UNITED STATES
DEPARTMENT OF THE INTERIOR
BUREAU OF LAND MANAGEMENTFORM APPROVED
OMB NO. 1004-0135
Expires: July 31, 2010**SUNDRY NOTICES AND REPORTS ON WELLS**
Do not use this form for proposals to drill or to re-enter an abandoned well. Use form 3160-3 (APD) for such proposals.5. Lease Serial No.
NMSF078095

8. Well Name and No.
MUDGE LS 239. API Well No.
30-045-11078-00-S110. Field and Pool, or Exploratory
BASIN DAKOTA11. County or Parish, and State
SAN JUAN COUNTY, NM**SUBMIT IN TRIPLICATE - Other instructions on reverse side.**

BP - San Juan Wellwork Procedure

MUDGE LS 023-DK 30-045-11078-00

Proposed Wellbore Diagram

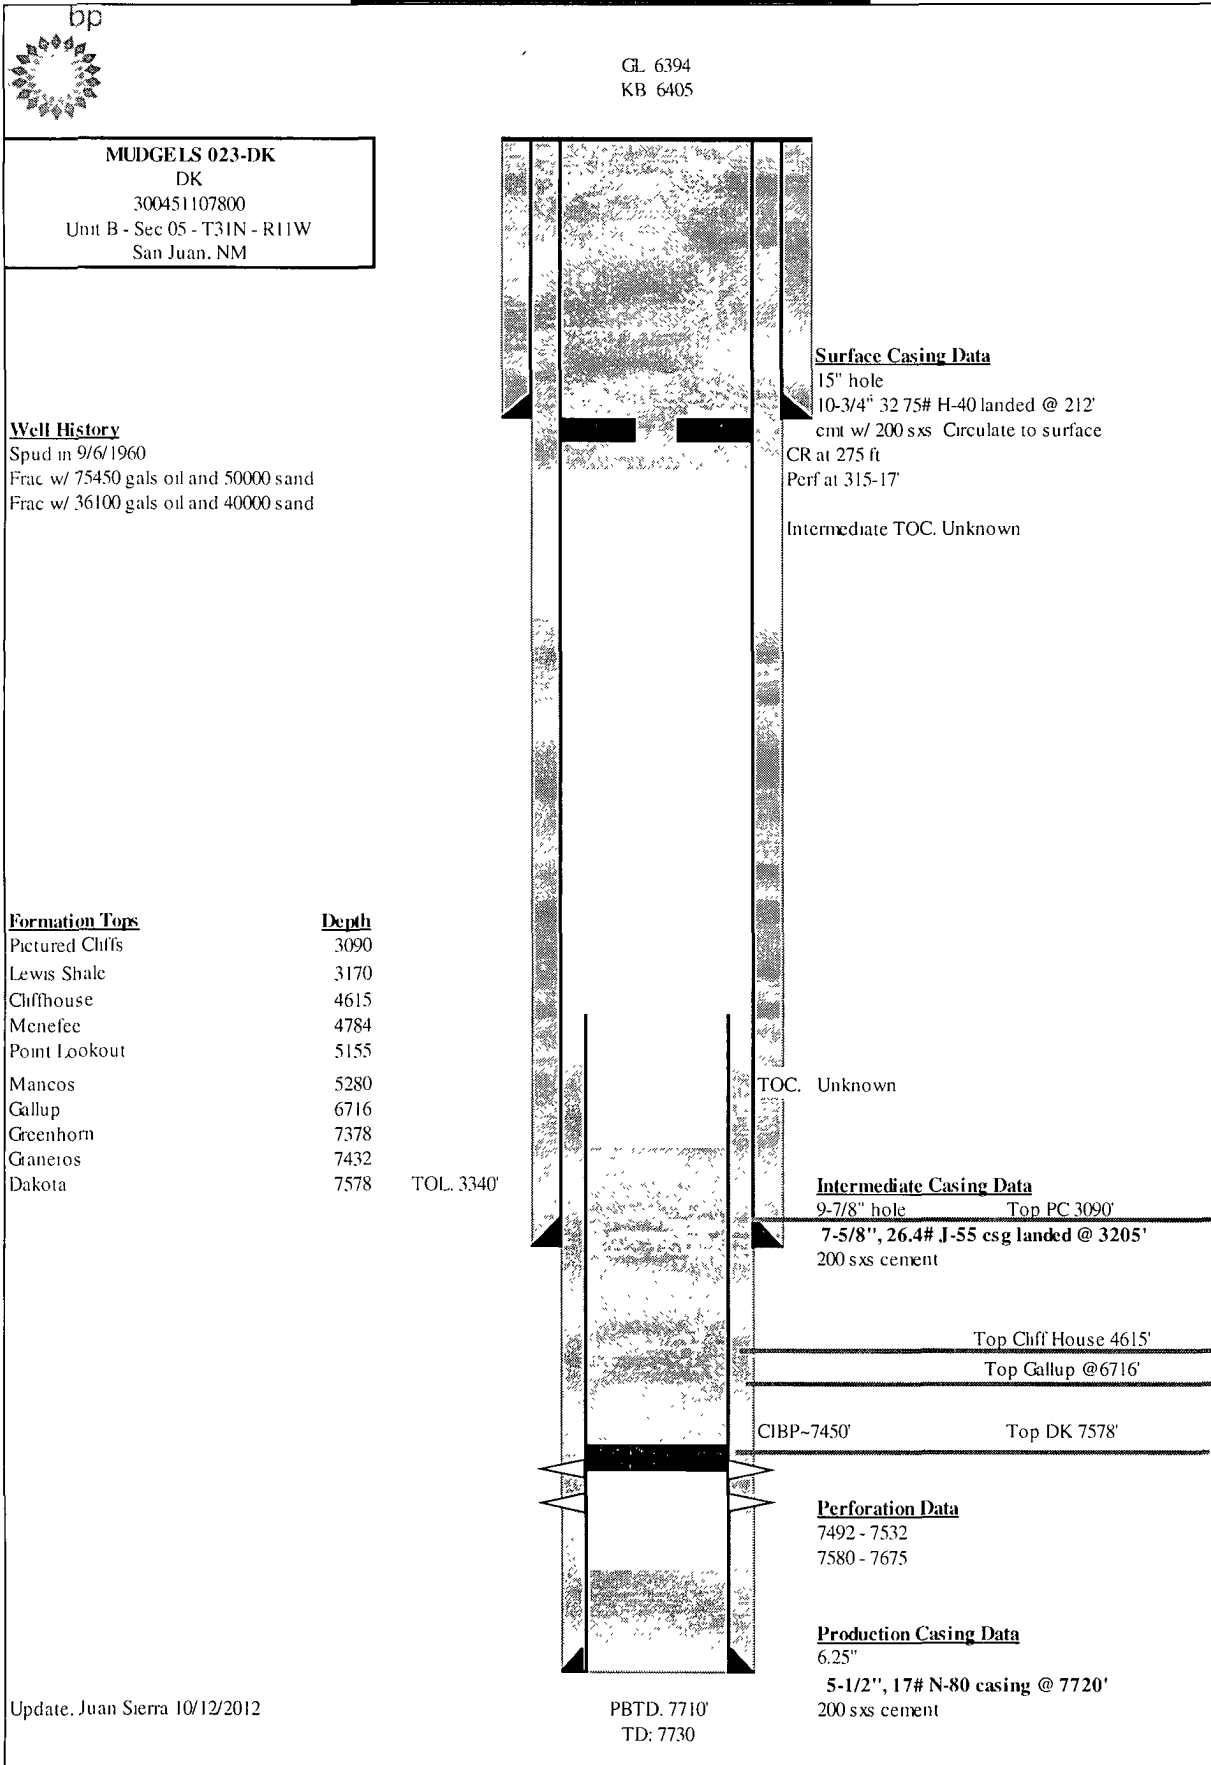
Changes to the plugging procedure on the Mudge LS 23:

- a) Place a cement plug from 3801' – 3701' to cover the Chacra top.
- b) Place the Fruitland plug from 2703' – 2603'.
- c) Place a 100' cement plug across the 5 ½" casing stub.
- d) Place the Kirtland plug from 1454' – 1354'.
